Application No. A/NE-TKL/837

Section 16 Planning Application for Temporary Open Storage of Recycling Materials and Metalware with Ancillary Facilities and Associated Filling of Land for a Period of 3 Years at Lots 86 (Part), 87 and 89 in D.D. 83 and Adjoining Government Land, Kwan Tei North, Fanling, New Territories

Submission of Further Information 2

Responses to Departmental Comments

11m Heavy Goods Vehicle
Overall Length 11.000m
Overall Width 2.500m
Overall Body Height 3.632m
Min Body Ground Clearance 0.427m
Track Width 2.500m
Lock-to-lock time 6.00s
Curb to curb Turning Radius 11.000m

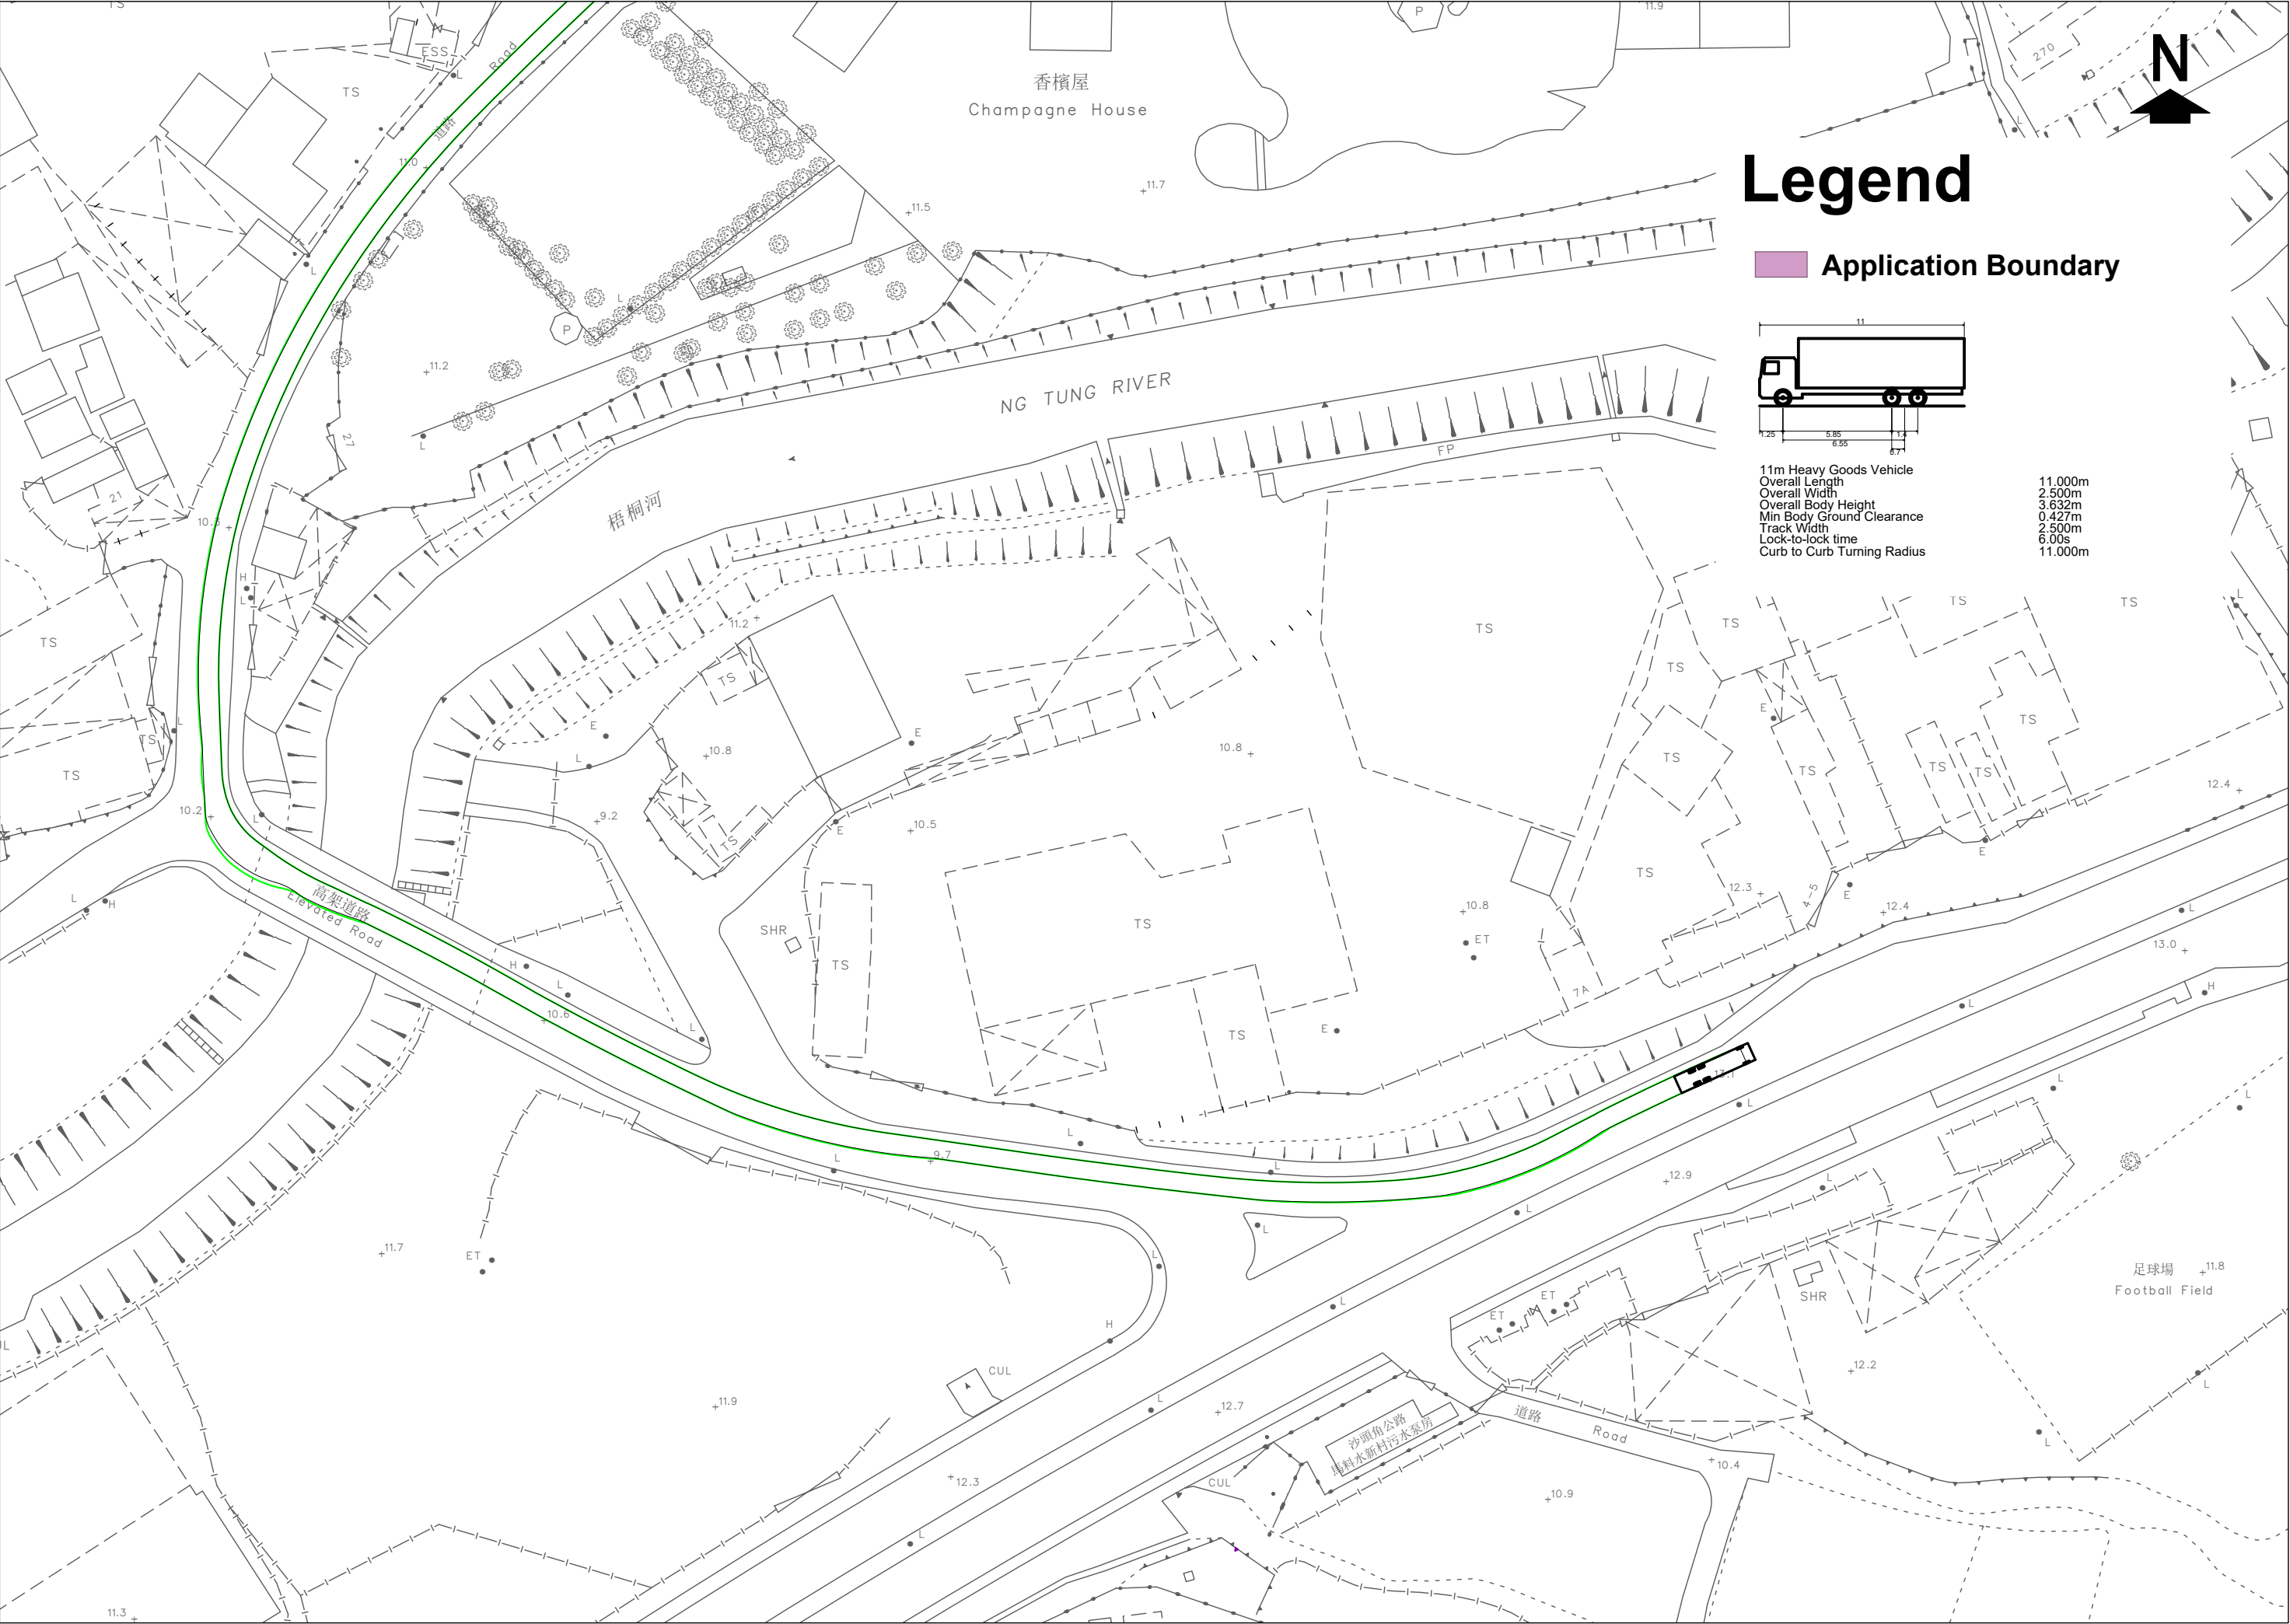
Item	Departmental Comments	Applicant's Responses
1. Comments from Transport Department received on 18.5.2026		
	- the dimension of good vehicles used for swept path analysis should follow the table 5.4.4.1 in Volume 7 of TPDM; and - the applicant should propose measures, such as installation of traffic warning signs and provision of passing bays, to ensure that the movement of site vehicles will not clash with the vehicles riding in opposite direction along the access road linking Sha Tau Kok Road - Lung Yuek Tau to the application site.	The revised swept path analysis is attached at Annex 1 of this FI submission. Please refer to Annex 2 for the proposed traffic warning signs along the access road, which are located on Government land. Upon approval of the application, the Applicant will apply to the relevant departments for permission for the installation of the signage.

Land Filling Plan

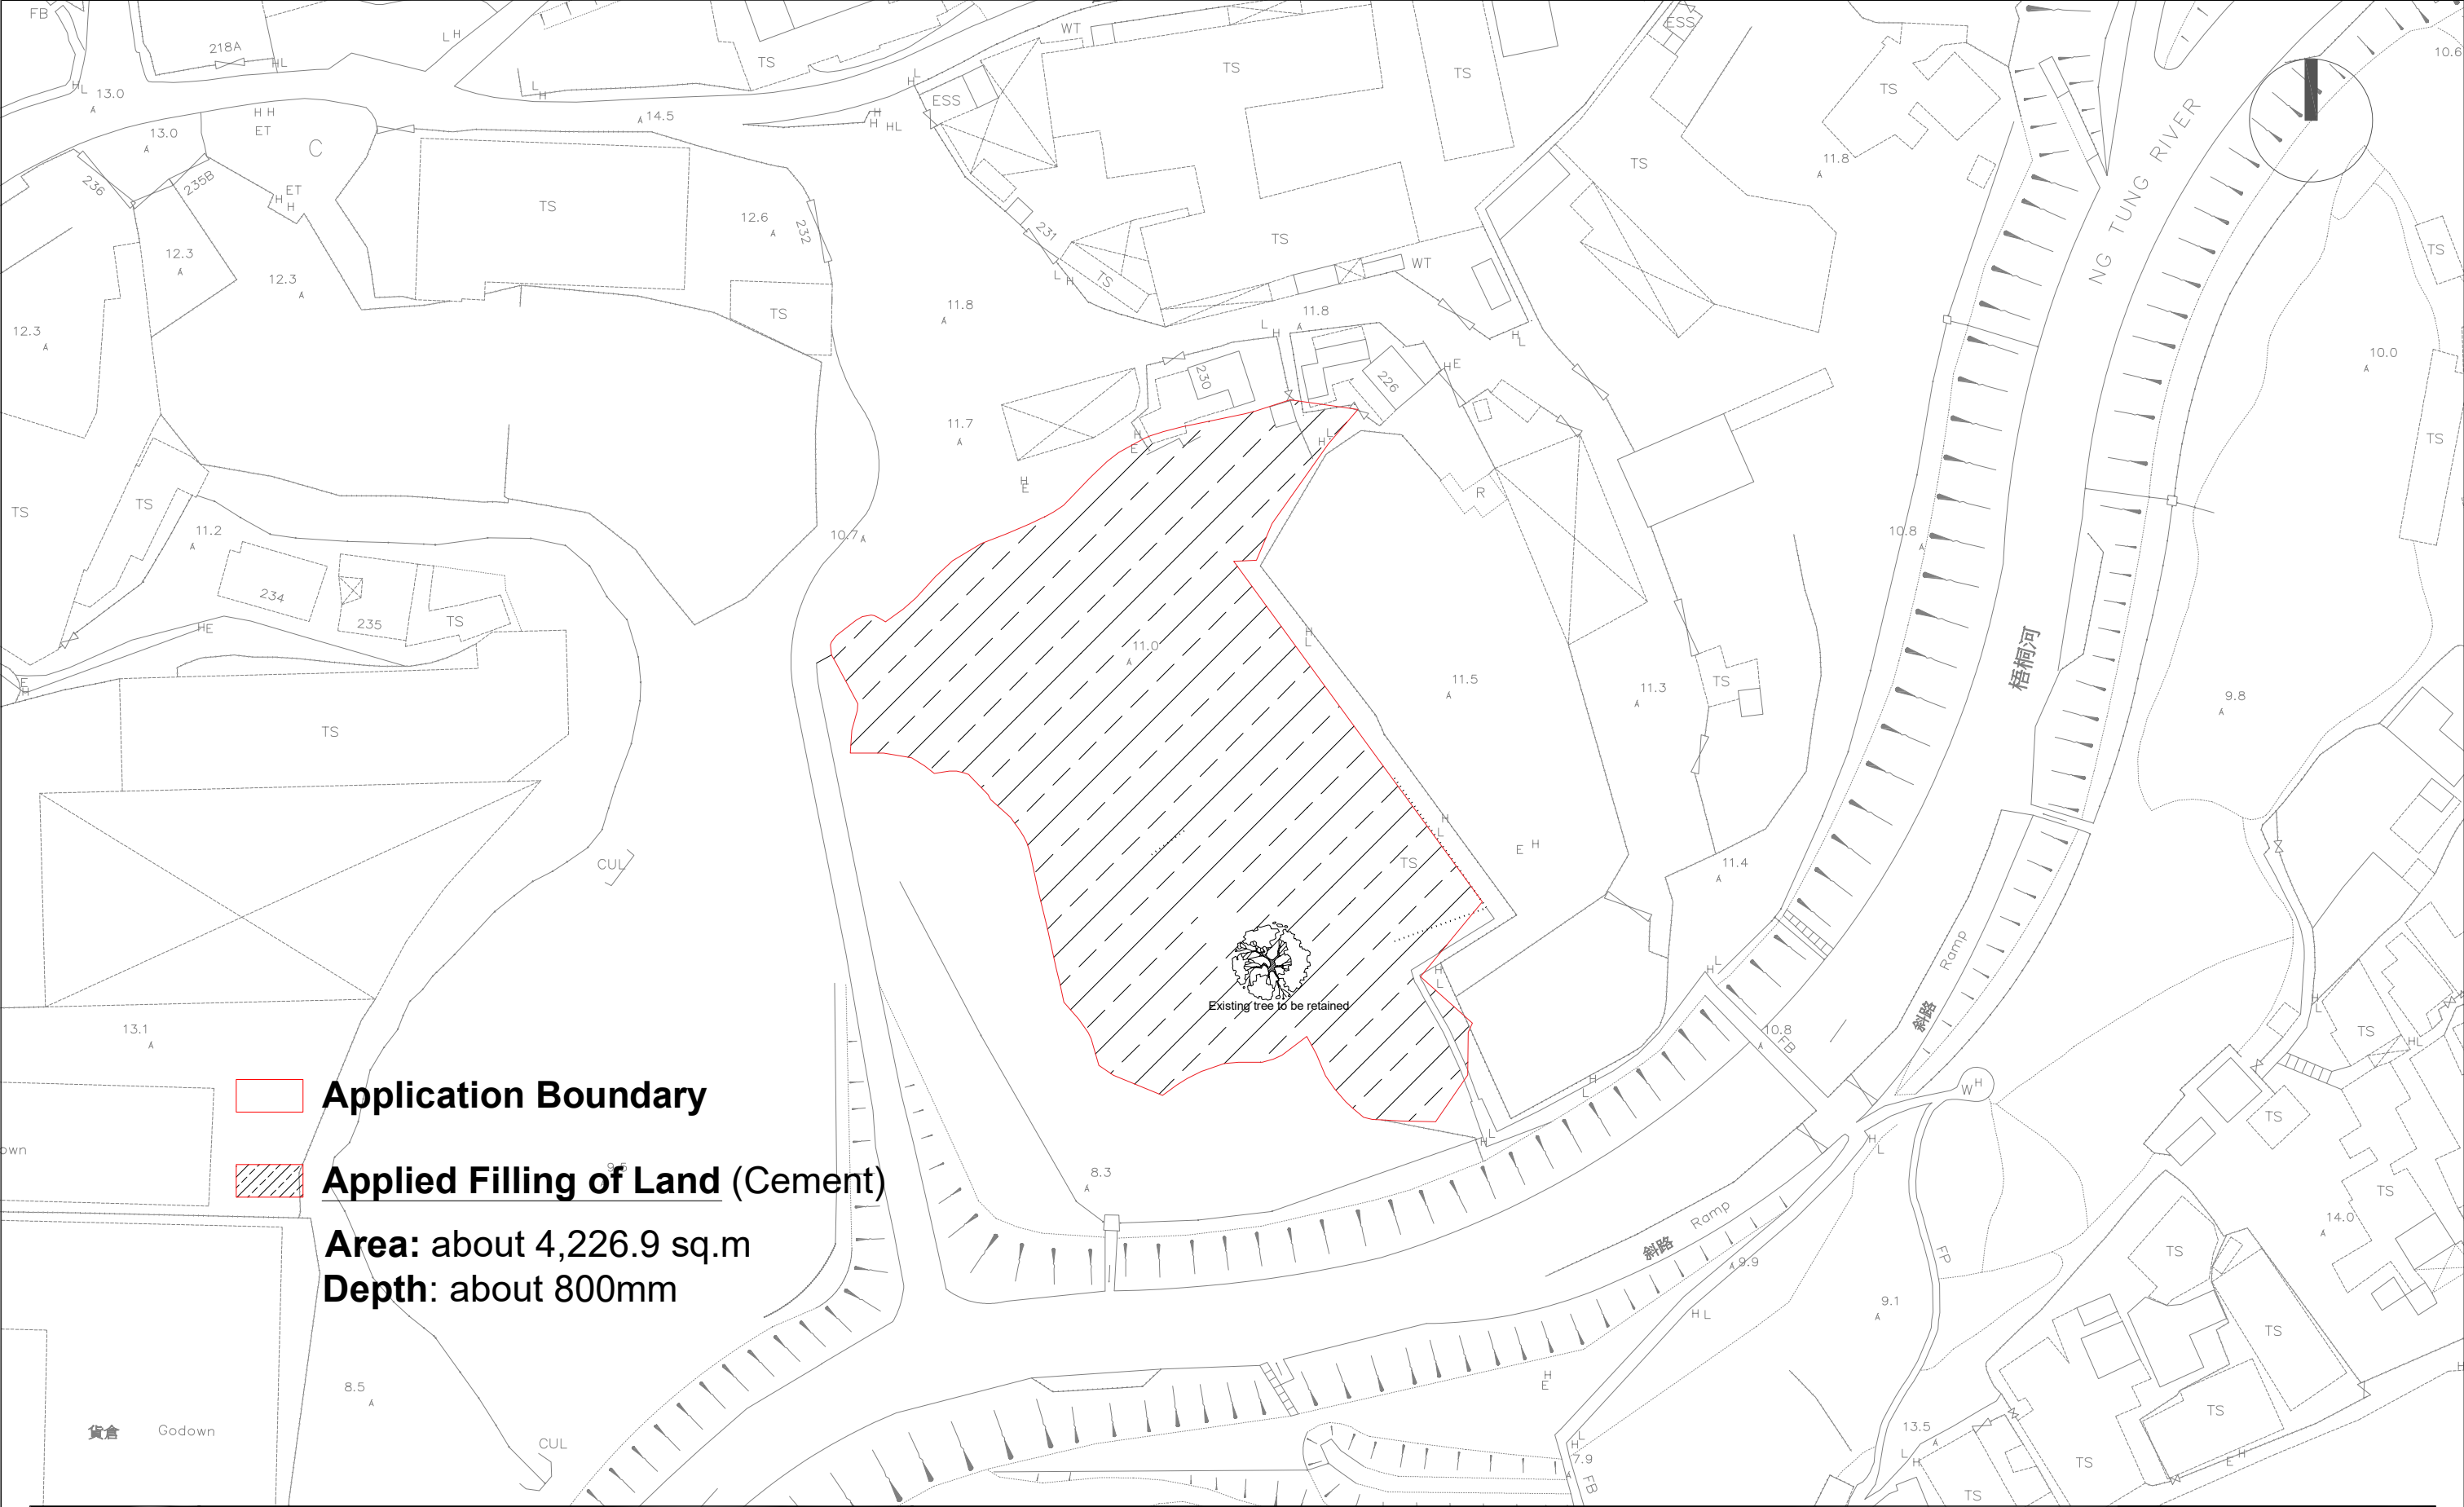
2. Comments from Planning Department received on 4.5.2026		
	As discussed previously, please also provide supplementary information on the filling of land at the application site.	Please be informed that the Application Site had already been paved prior to the Applicant's tenancy of the site. It is understood that the earlier filling of land was primarily carried out for site formation purposes for open storage use. The current applied filling of land is intended to regularise the previously filled area and reflect the present conditions of the Application Site. Accordingly, there will be no further filling of land in the future. The applied filling of land comprises approximately 4,226.9m² with a depth of 800mm. Please refer to Annex 3 for the land filling plan. At present, the highest level of the Application Site is about 11.4mPD, while the lowest level is approximately 9.7mPD. The site levels prior to land filling are estimated to range from about 8.9mPD to 10.6mPD.
